**PLANNING & ZONING BOARD
AGENDA ITEM 6A**

TOPIC: **PUBLIC HEARING** for Otter Crossing South Preliminary Plat and ALDI Site and Building Plan Review

To: Katie Larsen, Lino Lakes City Planner
From: Diane Hankee PE, Lino Lakes City Engineer
Date: March 5, 2025
Re: Otter Crossing South
Preliminary Plat Review
028173-000

To: Katie Larsen, Lino Lakes City Planner
From: Diane Hankee PE, Lino Lakes City Engineer
Date: March 5, 2025
Re: Aldi Store #154
Site Plan Review
028170-000

COVER SHEET

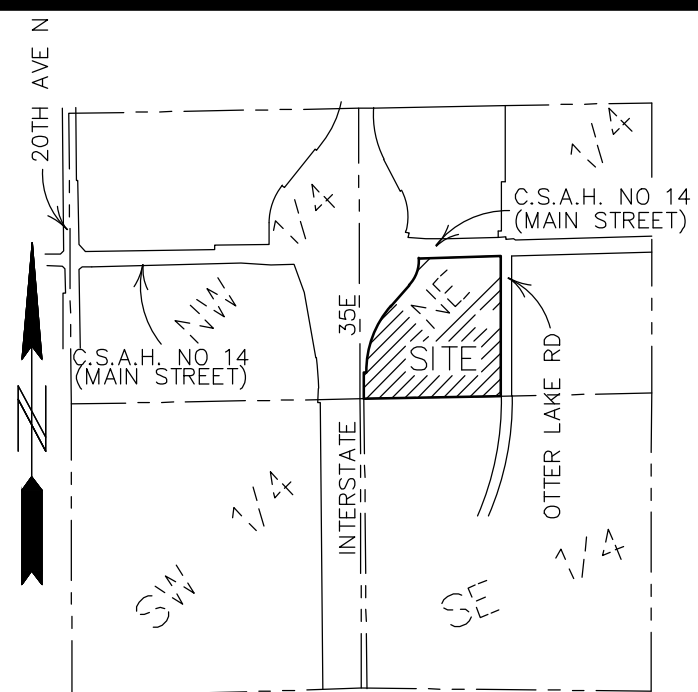
10. Revision dates shall be included on all applicable plan sheets.
11. Sheet 1, Cover Sheet (Otter Crossing South):
 - a. Remove red line crossing the proposed parking lot unless it has significance, then label.

NEIGHBORHOOD LAND USE PLAN

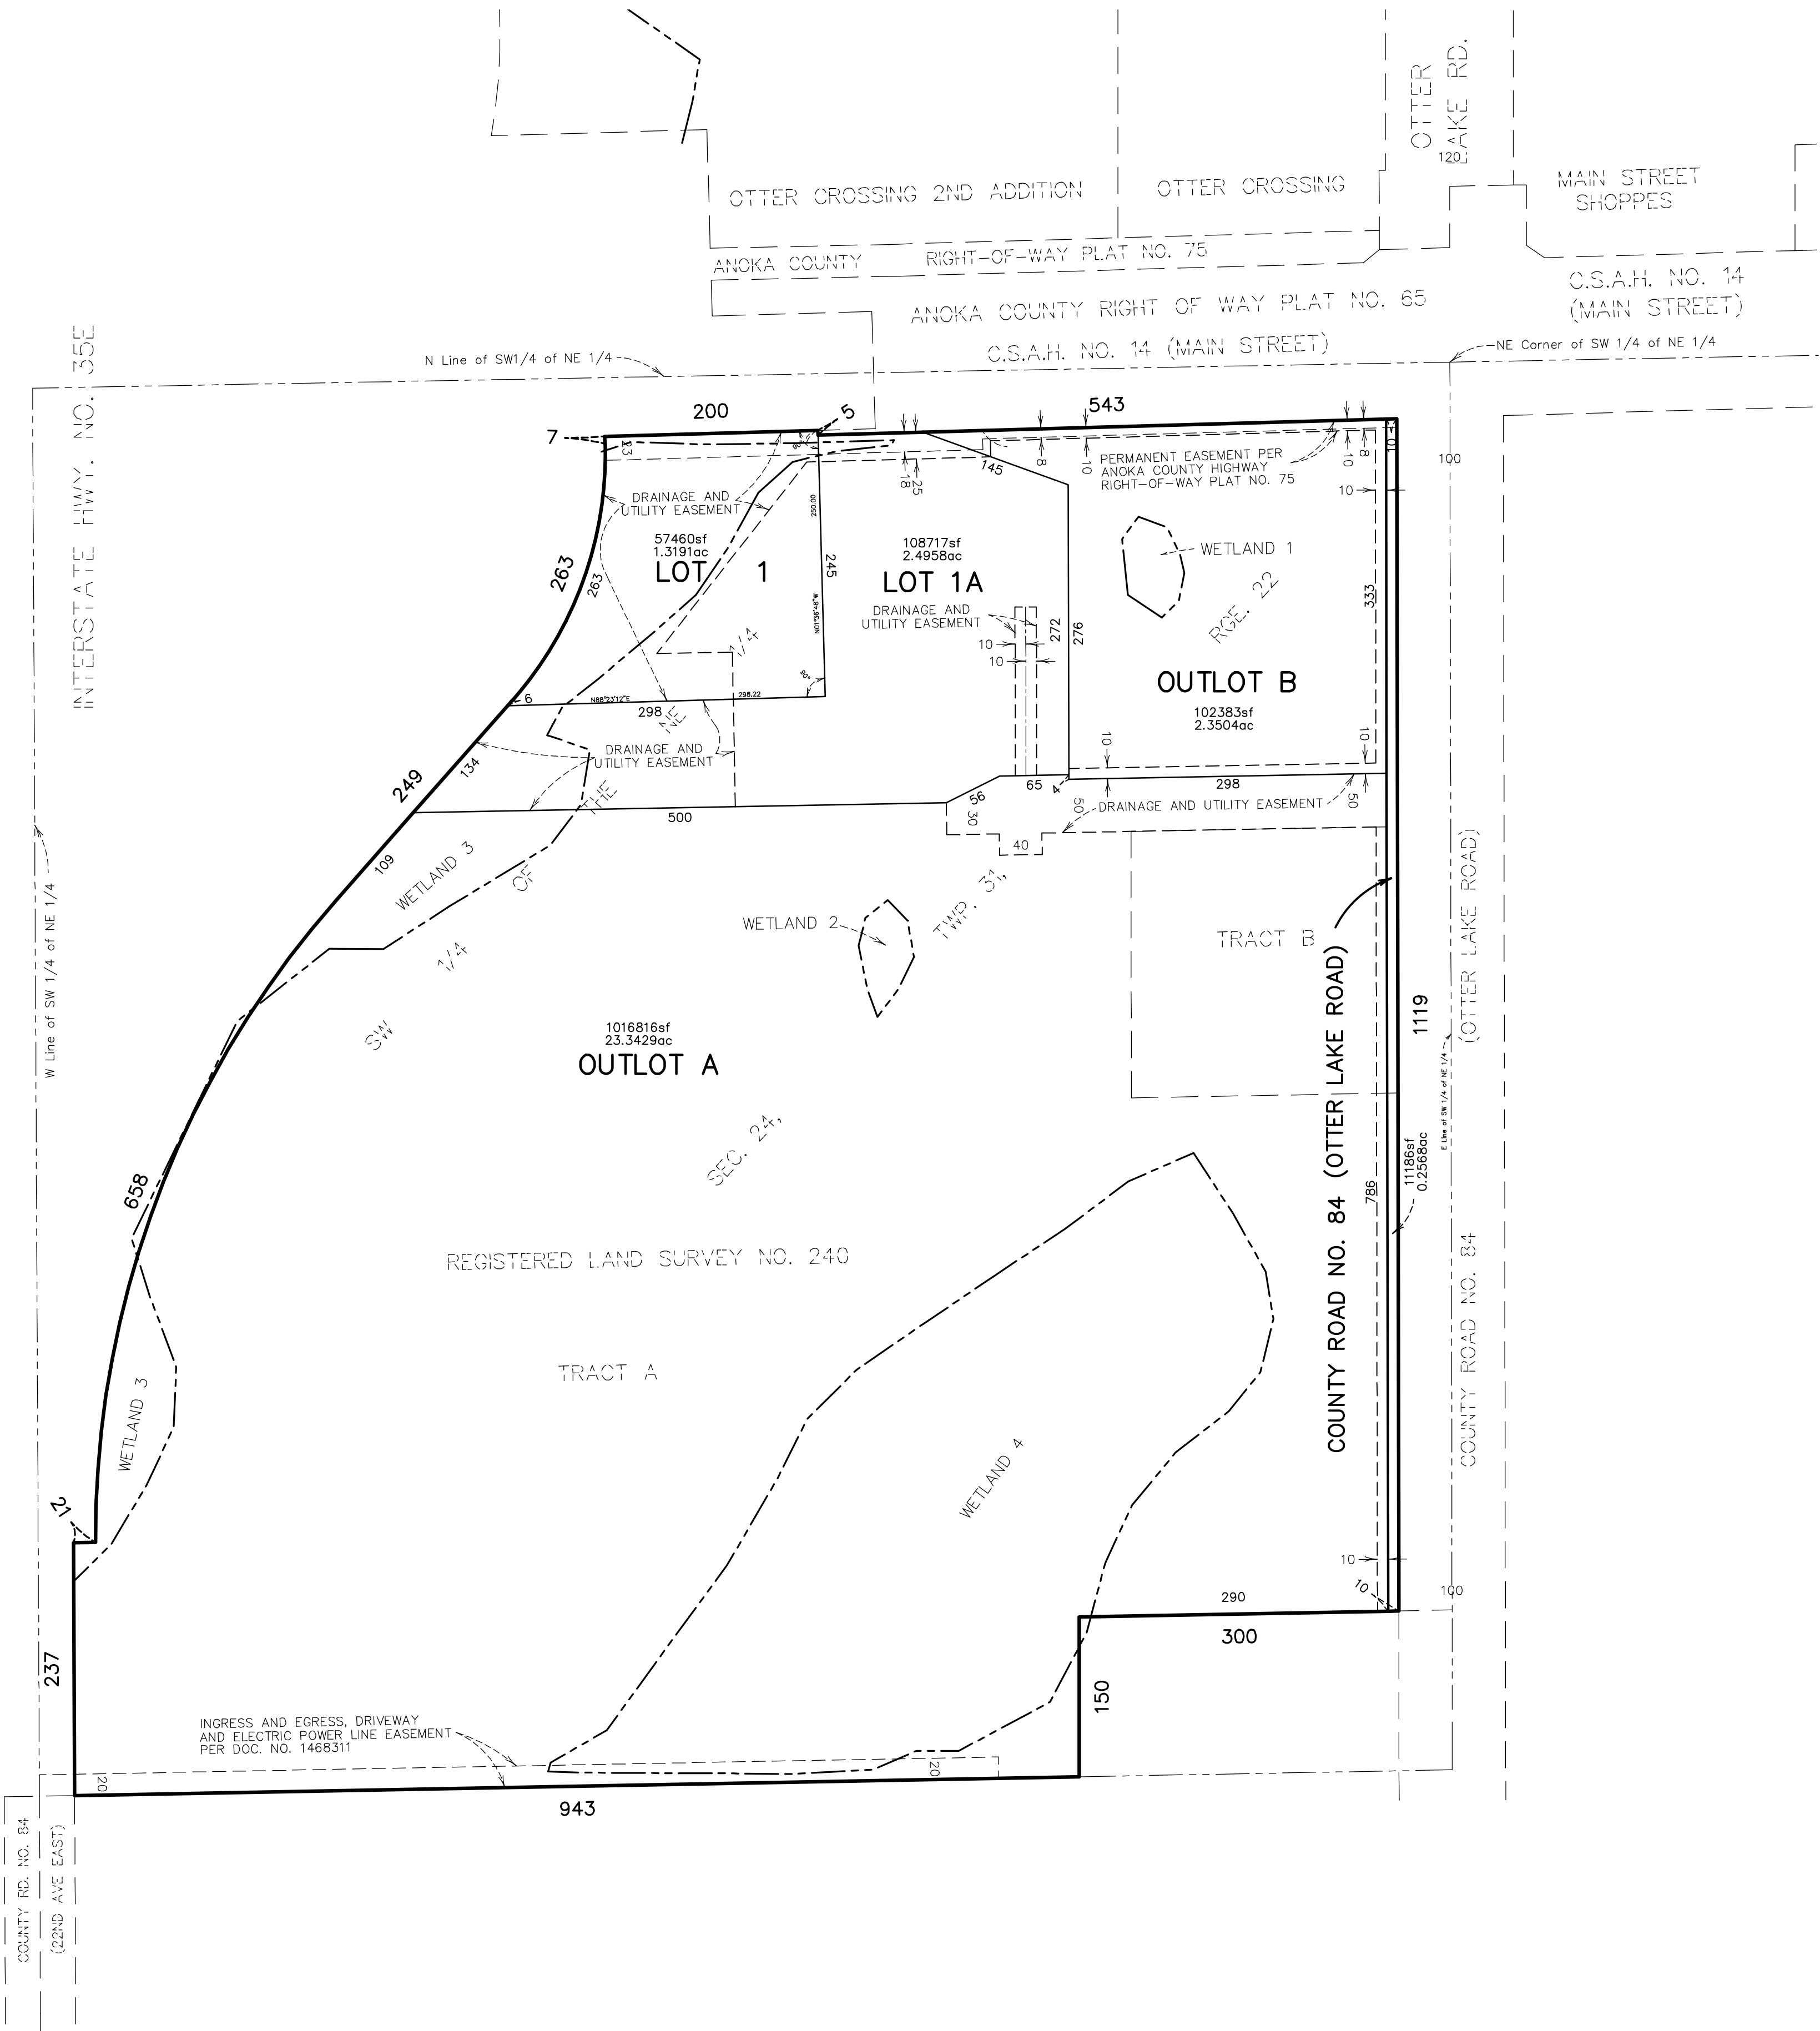
12. Sheet 5, Neighborhood Land Use Plan:
 - a. Remove red line crossing the site unless it has significance, then label.
13. Sheet 6, Preliminary Plat:
 - a. Add all existing easements and document numbers.

MASTER PLAN

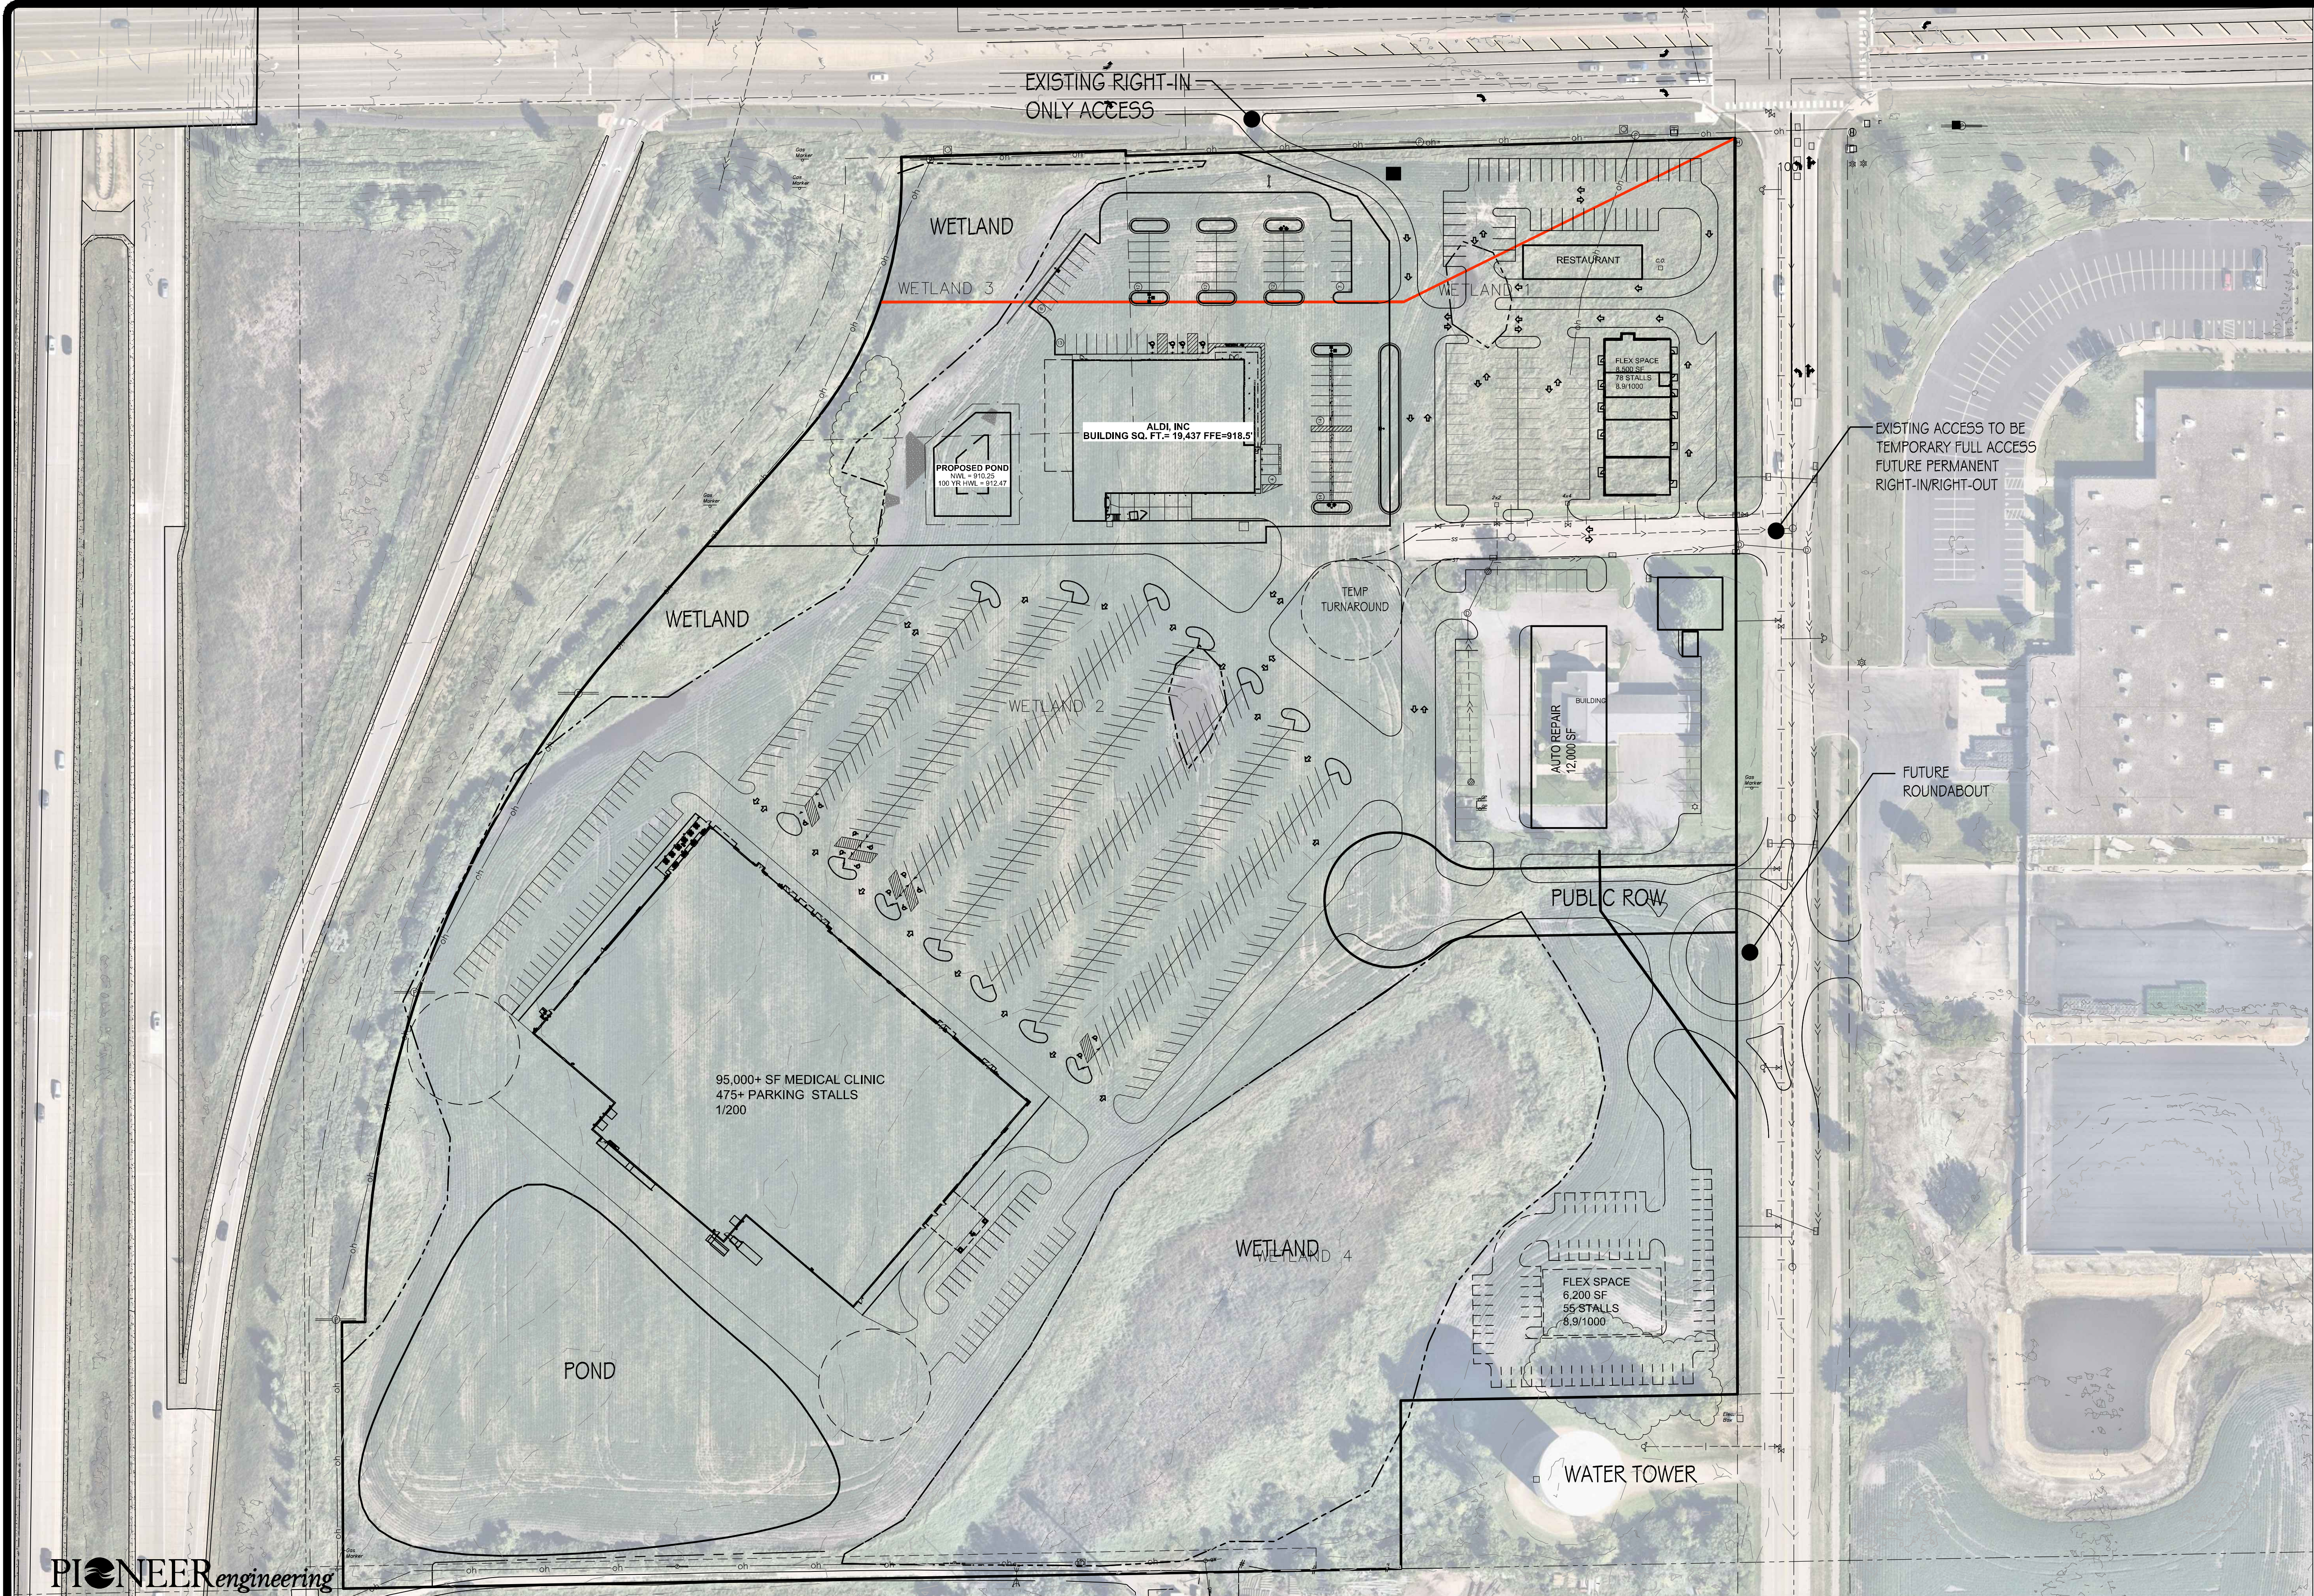
- g. Add the 2040 Comprehensive Land Use is commercial.
 - h. Add the Zoning is GB, General Business.
 - i. The scale bar is incorrect.
14. Sheet 7, Master Plan:

- a. Remove red line crossing the site unless it has significance, then label.
15. Sheet C-010, Site Data Sheet (ALDI):
- a. Show parking lot calculations.
